## TOLEDO - LUCAS COUNTY PLAN COMMISSIONS

REF: SUP-7002-23

SUBJECT: Special Use Permit for a School at 6004 Hill Avenue

SITE PLAN

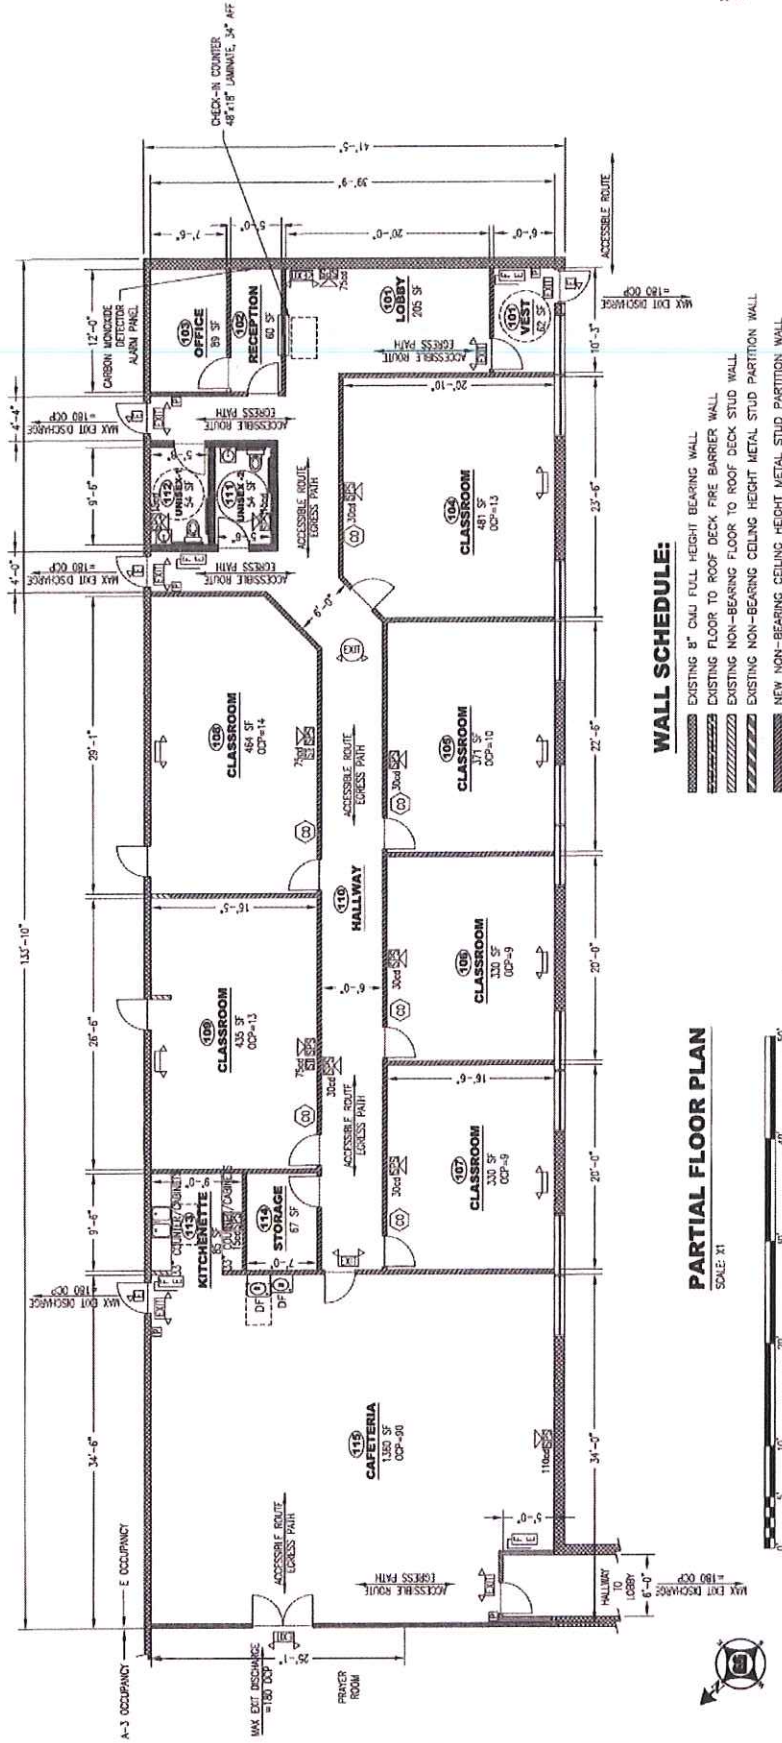
In addition to that, thirty-nine (39) parking spaces are provided at the adjacent property at 41 N. Holland-Sylvania Road owned by the applicant. The site plan does not show any bicycle parking spaces. Twenty-six (26) bicycle spaces are required for the school. This shall be shown on a revised site plan.

21. Per TMC§1107.0304 one (1) space paved off-street area for dropping off and picking up students at the school must be provided **Not acceptable as depicted. Drop-off and pick-up space shall be shown on a revised site plan.**

22. Per TMC§1107.0900, twenty-six (26) bike parking spaces are required. **Not acceptable as depicted. Bike parking spaces shall be shown on a revised site plan.**

- a. A five-foot (5') greenbelt is required along the property line fronting Hill Avenue and Holland-Sylvania Road. The frontage greenbelt shall include a solid evergreen hedge to screen parking in the front of the property and prevent headlights from being seen from the right-of-way. **Not acceptable as depicted on site plan. Applicant shall submit a landscaping plan showing the greenbelt buffer;**

- b. TMC§1108.0204(B)(9) requires perimeter landscaping to be installed along any parking lot area adjacent to a street, place, or driveway, or which is visible from an immediately adjacent property, and must include a continuous shrub row with a minimum height eighteen inches (18"). Perimeter landscaping must consist of a landscape area at least 10 feet in width, exclusive of sidewalks, walkways, trails, or right-of-way and must be located between the parking lot and the property line. **Not acceptable as depicted. Applicant shall submit a landscaping plan showing perimeter landscaping along the north and west property lines subject to review and approval of the Planning Director;**
